Land at Ridgeway Lane and Lower Pennington Lane, Lymington

Pennington and Lymington Lanes Society

Road Safety Assessment

December 2021

Risk 5: Increased risk of collision associated with the development access proposals on Ridgeway Lane

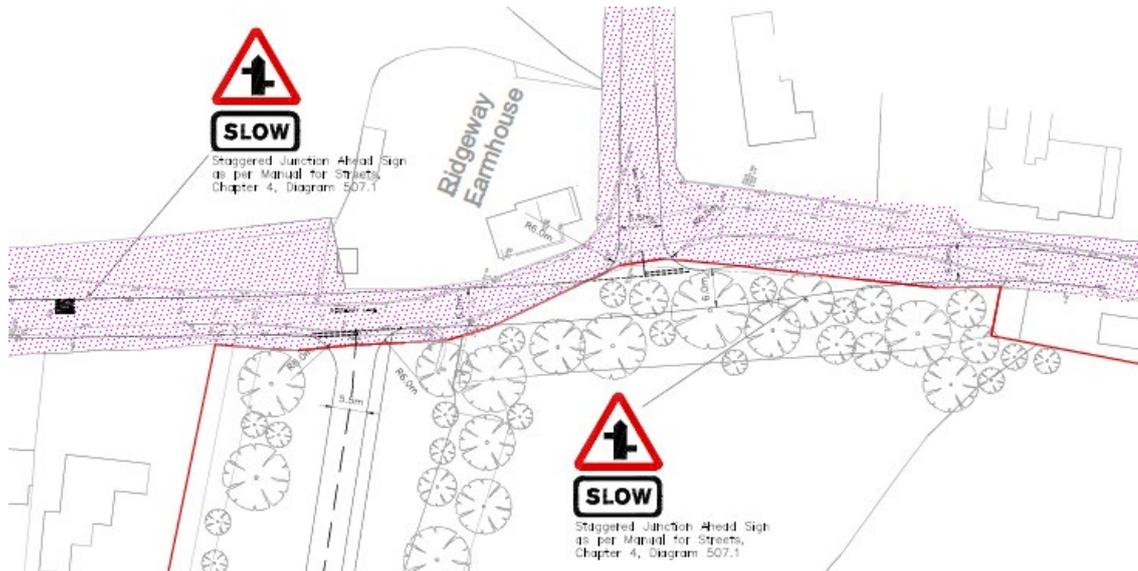
3.2.8 The access to the proposed development on Ridgeway Lane involves the straightening and widening of the carriageway with staggered priority junctions for Poles Lane and the site access, as illustrated on the extract below. It was observed and understood that there are a large number of pedestrians walking north / south along Ridgeway Lane at this point, including to / from the Chequers Public House and the recreational paths along the coast.

3.2.9 The junction geometry, visibility and forward visibility on Ridgeway Lane would be provided to a more suitable standard, but there are no footways proposed and there is concern that the proposed arrangements would increase vehicle speeds on an unsuitable country lane between the Chequers public house to the south and Woodside Park in the north. This would increase the risk of collisions between vehicles and between vehicles and non-motorised road users and subsequent injuries to non-motorised users or vehicle occupants.
